ADDENDUM NUMBER ONE

**DARLA MOORE SCHOOL OF BUSINESS CONSTRUCTION – BP-2 STRUCTURE
UNIVERSITY OF SOUTH CAROLINA
STATE PROJECT NUMBER H27-6069-AC-2**

DATE OF ISSUE: January 12, 2012

SCALE :
1/4" = 1'-0"
SHEET NUMBER :
A-SK-012

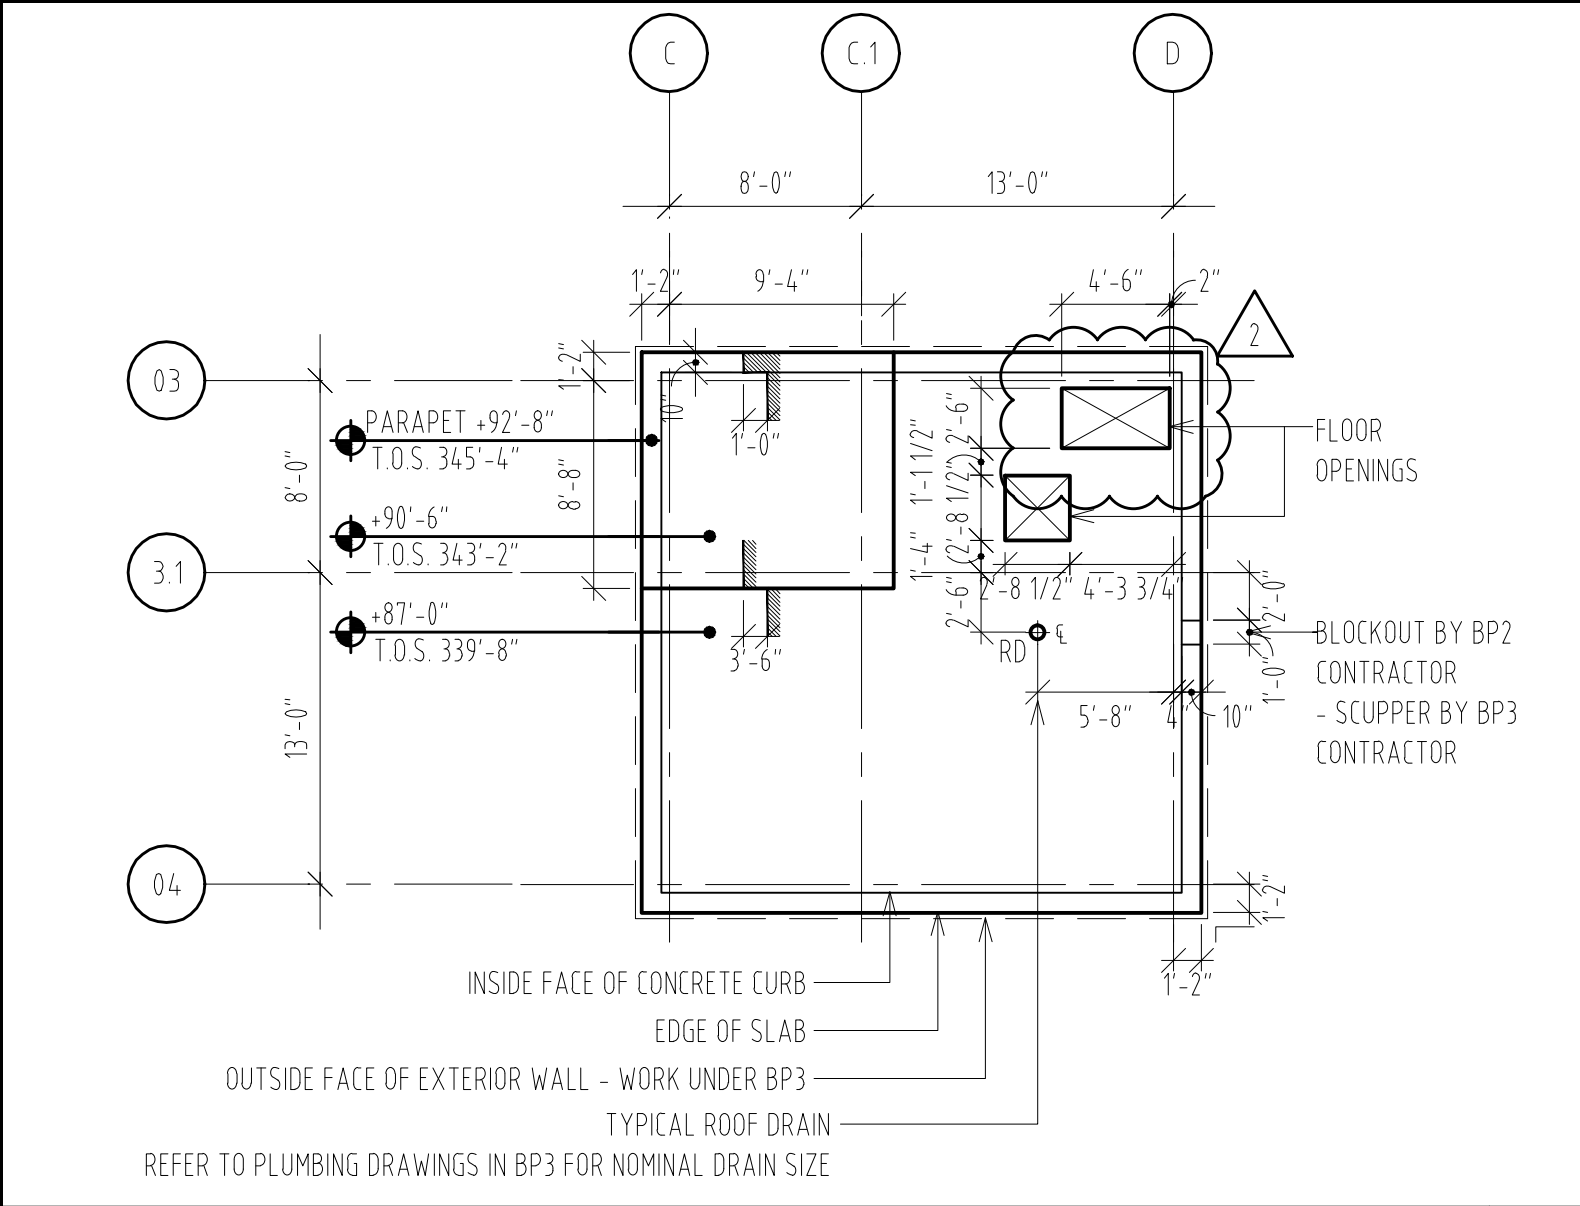
13.	Section sheet A4212, A4222, A4242: Refer to attached sketch A-SK-012 – section at cores 1, 2, 4 Level 5 roof to core roof. Raise core perimeter walls by 1'-0".

SHEET NUMBER :
A-SK-017

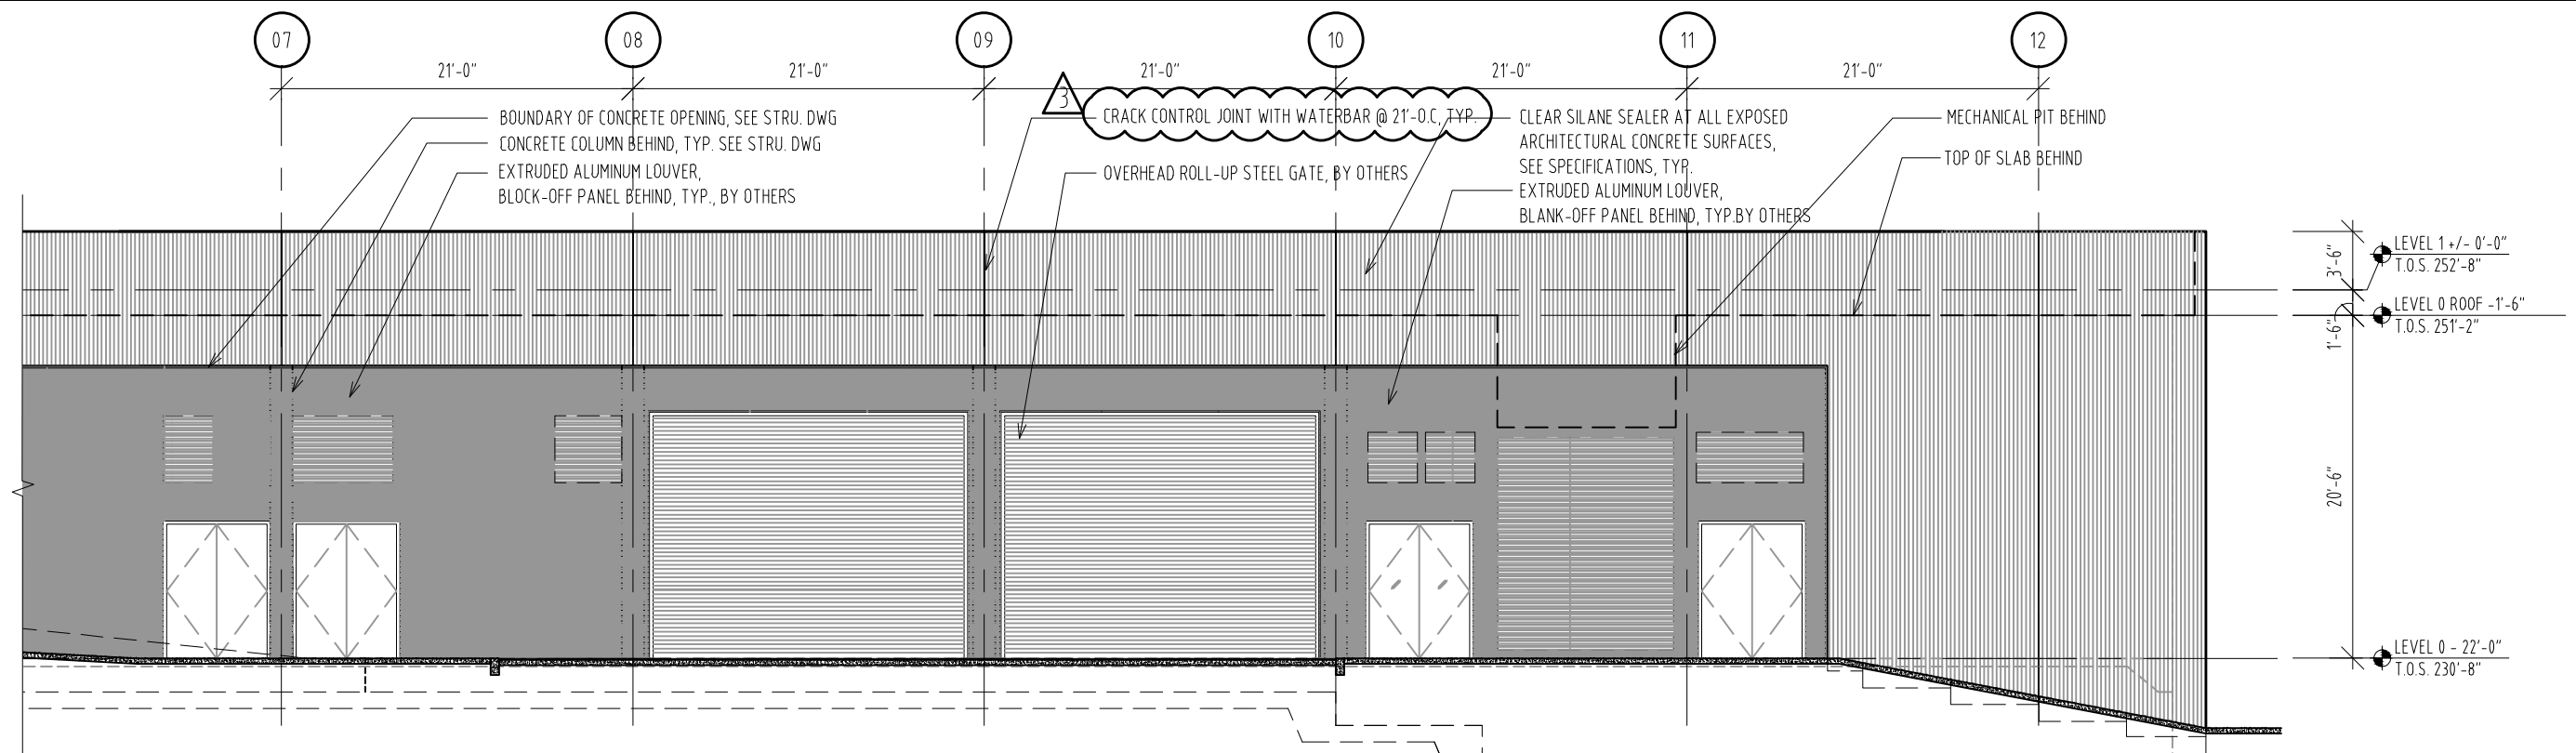
18. Detail sheet A4191: Refer to attached sketch A-SK-017 – typical foundation detail. Revised note to read “perforated plastic pipe foundation drain wrapped in filter fabric”. Add continuous waterstop on foundation as location shown in sketch.

SHEET NUMBER :
S-SK-002

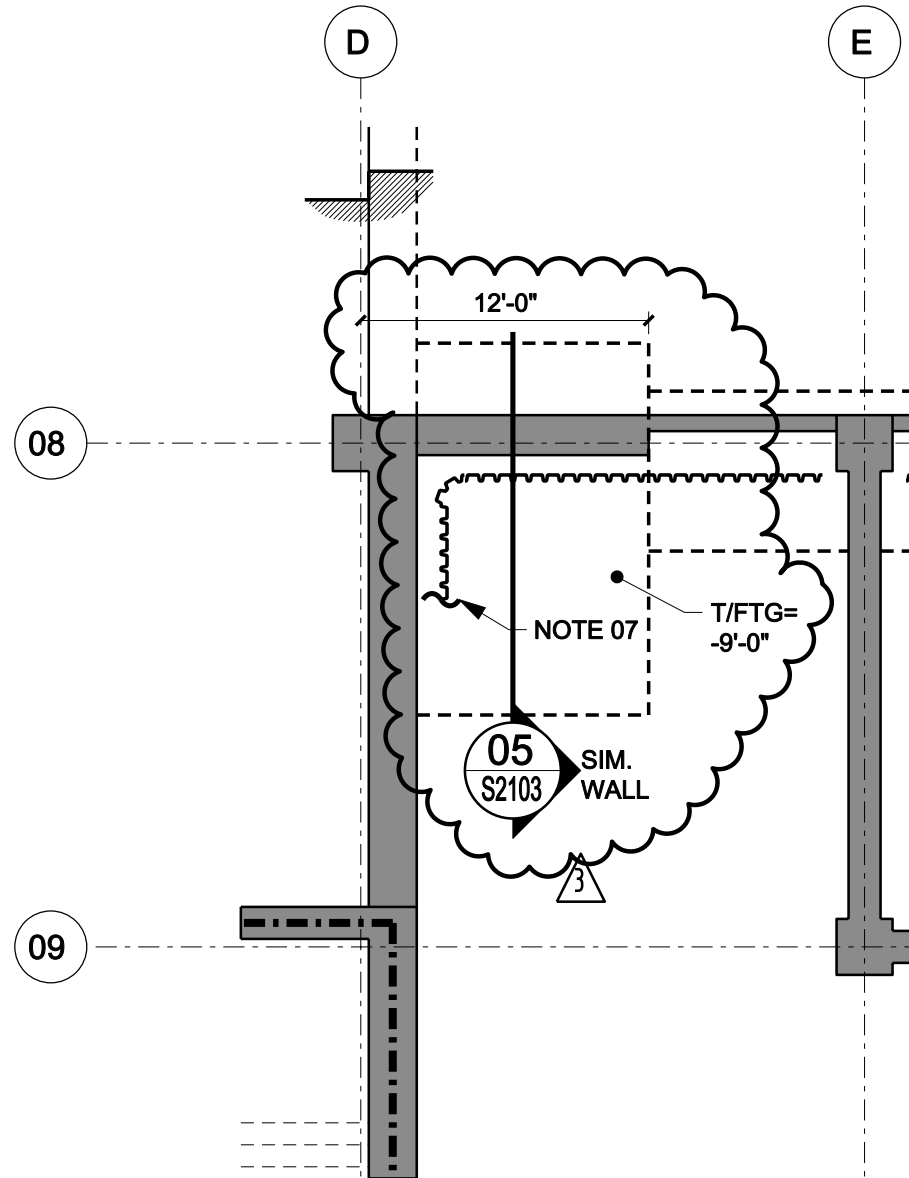
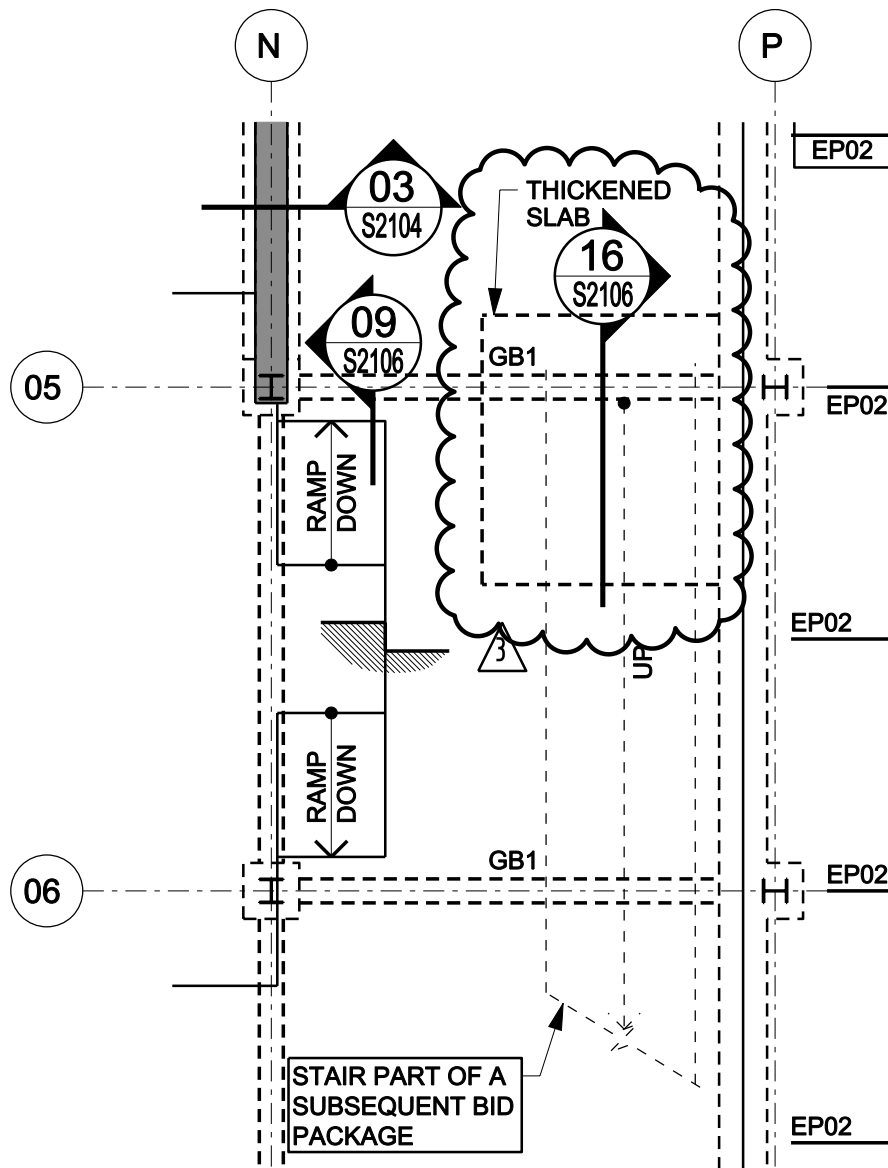
25. Plan sheet S1100F: Refer to attached sketch S-SK-001 – added footings with grade beams along Greene Street for stair and ramp support.
26. Plan sheet S1100.1A: Refer to attached sketch S-SK-002 – revised retaining wall and footing at West tunnel.

SHEET NUMBER :
S-SK-003

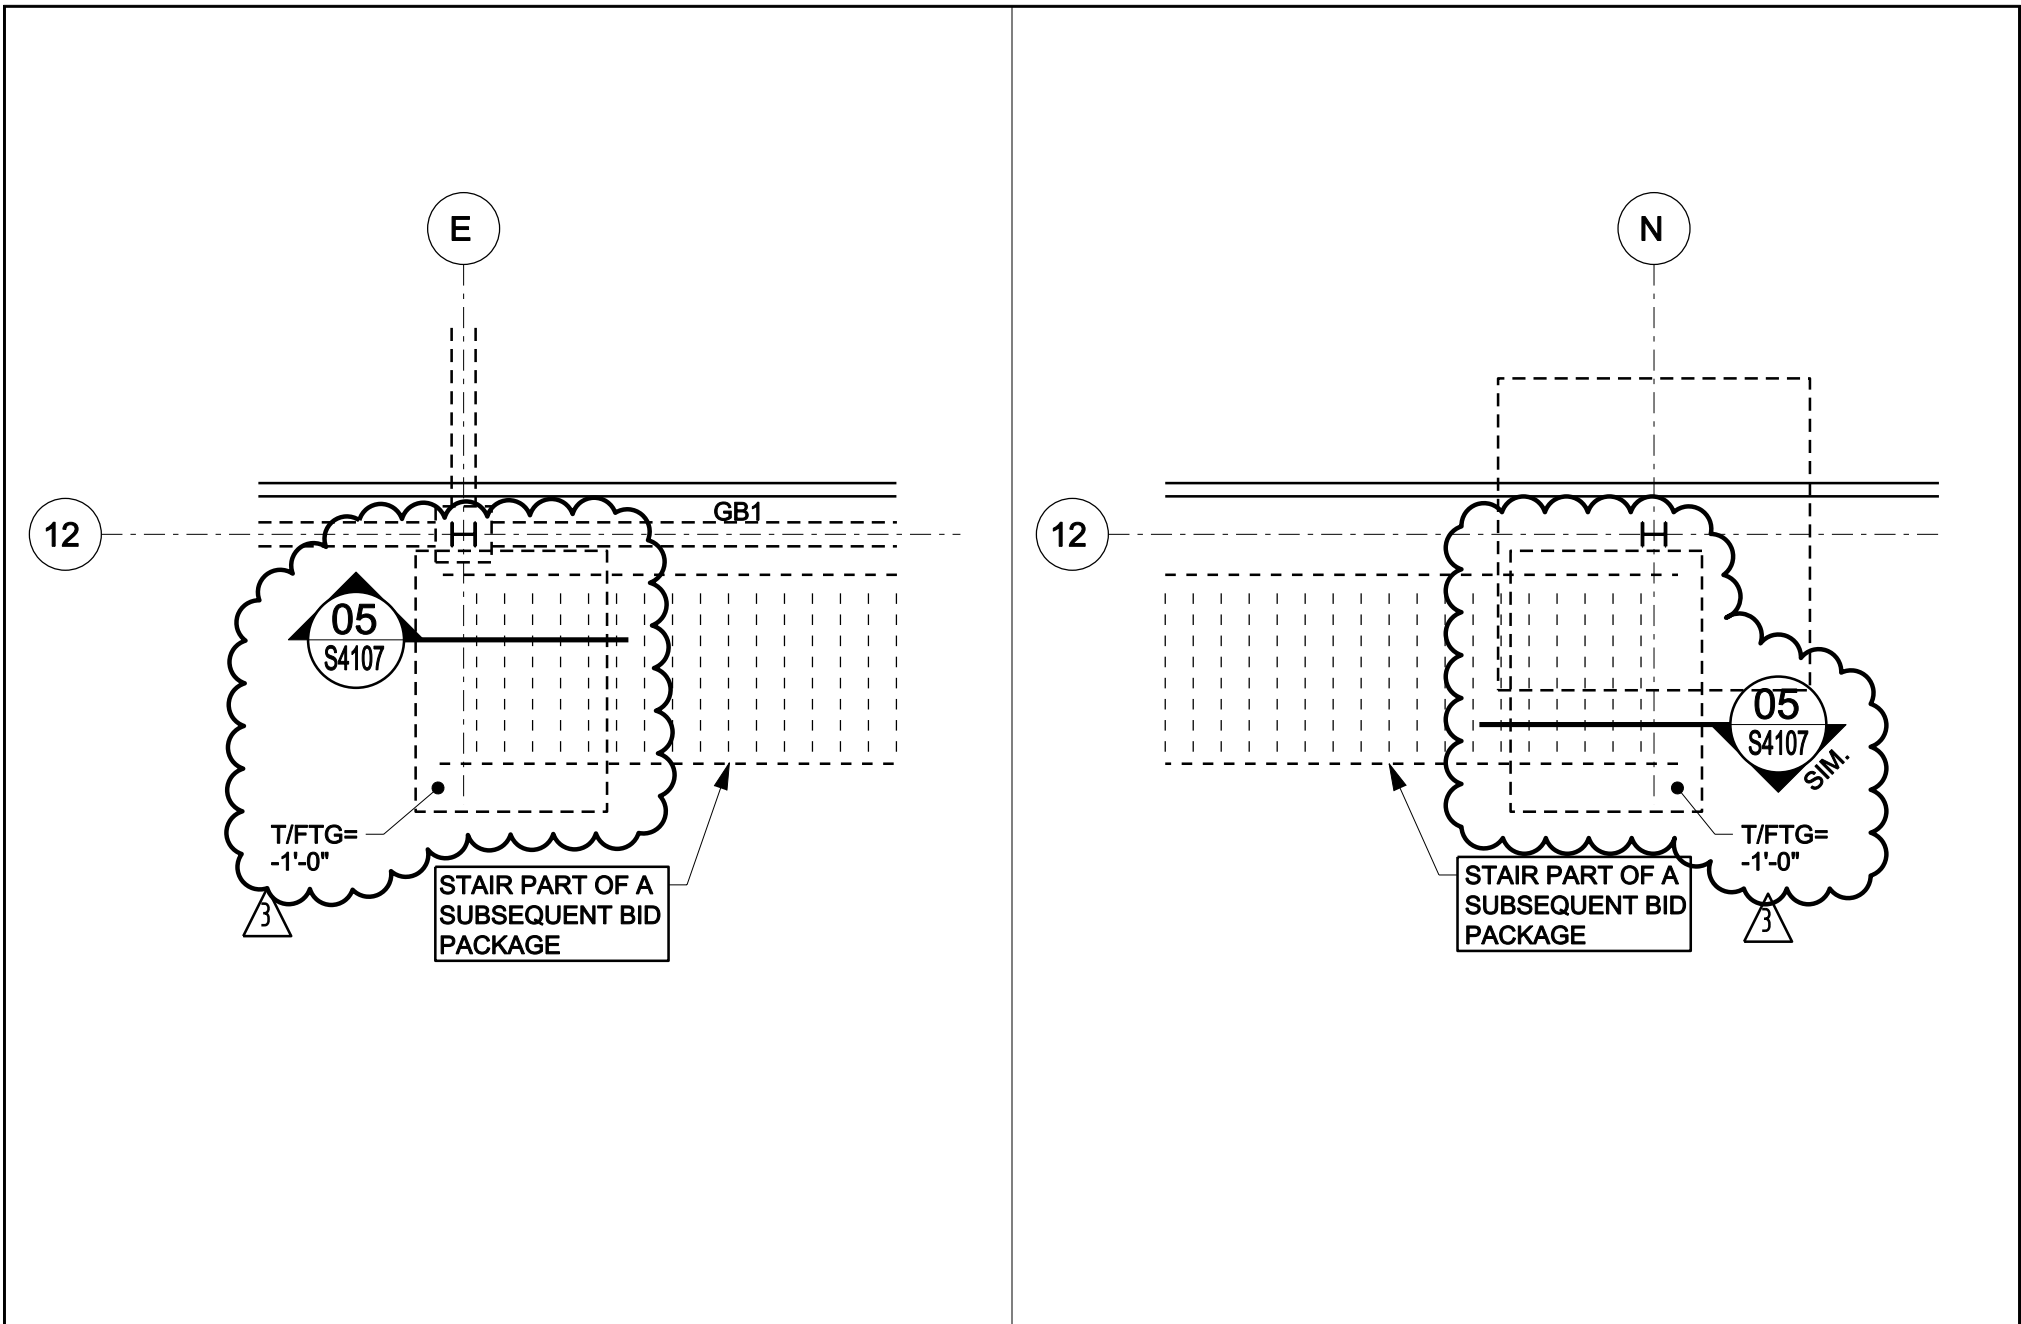
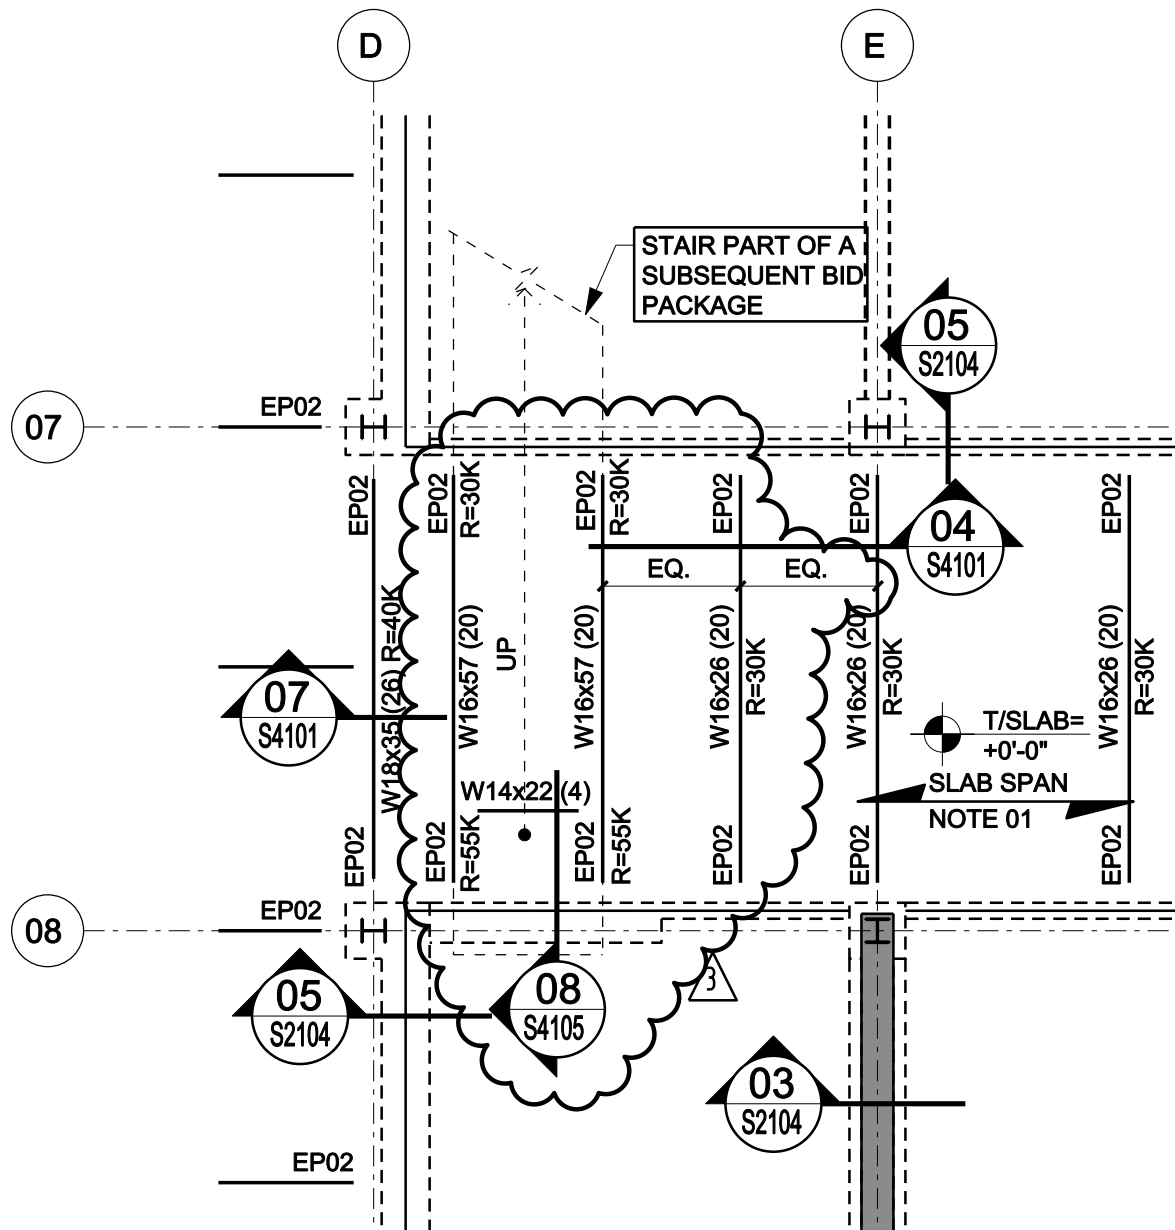
27. Plan sheet S1110A: Refer to attached sketch S-SK-001 & S-SK-003 – added footings with grade beams along Greene Street for stair and ramp support. Revised thickened slab-on-grade area at East stair landing.
